TECHNICAL REVIEW COMMITTEE  
Development Project Report

| Date Issued:                          | June 12, 2019, <b>Updated June 26, 2019</b>  |
| Project Name:                         | Young's Long Plat and Development Standards<br>Variance #19-01   |
| Project Description:                  | A Long Plat and Development Standards Variance application requesting to subdivide approximately 3.35 acres into 7 single family residential lots within the RS-100 zone. The applicant is also requesting a variance to LMC 18.14.100 regarding cul-de-sac lengths. |

**PRELIMINARY KAYSER LONG PLAT**  
 A PORTION OF THE SE QUARTER OF THE NW QUARTER OF SECTION 19,  
 TOWNSHIP 40 NORTH, RANGE 3 EAST OF W.M.,  
 WITHIN THE CITY OF LYNDEN, WHATCOM COUNTY, WASHINGTON

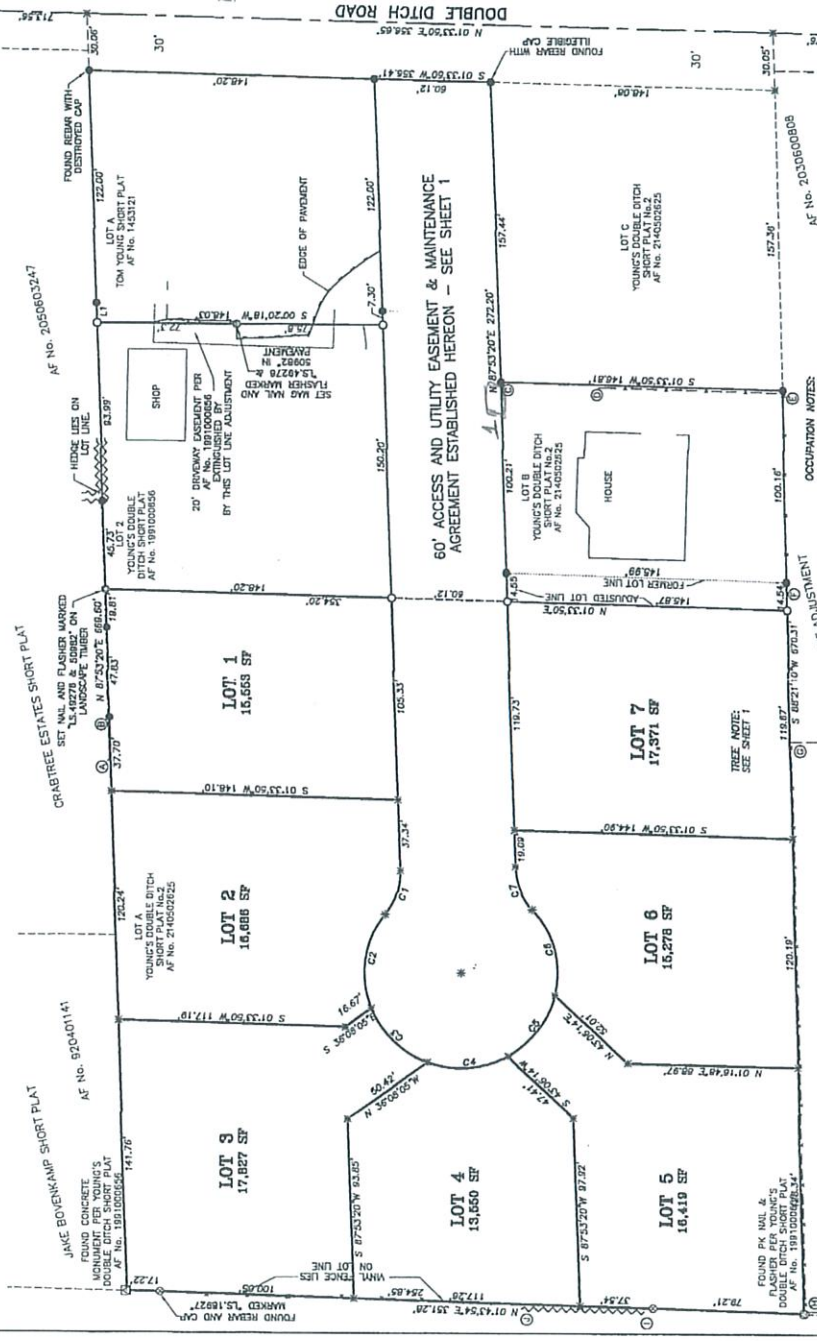
2. *Utility Easements:* Per 18.14.075, the proposed plat must identify the required 5-foot utility easements around the interior property line of all lots. Revise plat map to include this easement on the face of the plat.
3. *Tree Note:* The character of the Double Ditch neighborhood includes the presence of large trees intermingled among the residences. This character was emphasized with the requirement for a tree inventory and report placed on the previous LLA (Young's Double Ditch LLA, AF #2018-0501734).

Provide tree inventory showing trees greater than 12" DBH and how these relate to the proposed plat. This inventory and report shall be updated prior to preliminary plat approval. Impacts to large trees will require mitigation.

Provide a planting plan for the plat. If those boundary trees are no longer present, applicant will be required to plant additional trees (native conifers) along the boundary. Note protected planting areas for these boundary trees on the face of the plat.

5. *Utility Easements:* Revise plat to show the required 10 foot utility easement along the frontage of each lot.
6. *Stormwater Advisory Comments*
  - a. A stormwater management plan prepared by a professional engineer will be required for this development and must be approved by the City of

- a. As per 6.2 (M) of the City of Lynden Project Manual for Engineering Design and Development Standards, the water mainline must be extended to the north side of the proposed plat. Show easements as appropriate on the face of the plat.
- b. Be advised, each house and/or unit within this plat must be individually metered. Water meters must be located within the City right-of-way.

- a. Be advised, sanitary sewer and water system design and construction must meet the requirements of the City of Lynden Engineering Design and Development Standards.
- b. As per 7.2 (P) of the City of Lynden Project Manual for Engineering Design and Development Standards, sanitary sewer must be extended to the north side of the proposed plat. Show easements as appropriate on the face of the plat.

10. *Street Addressing:* Be advised, address numbers must be clearly posted on each house to assist in efficient fire aid response.
11. *Hydrants:* The installation of a fire hydrant is required within the cul-de-sac. The final hydrant location will be determined upon review of civil plans and must be approved by the Fire Department.
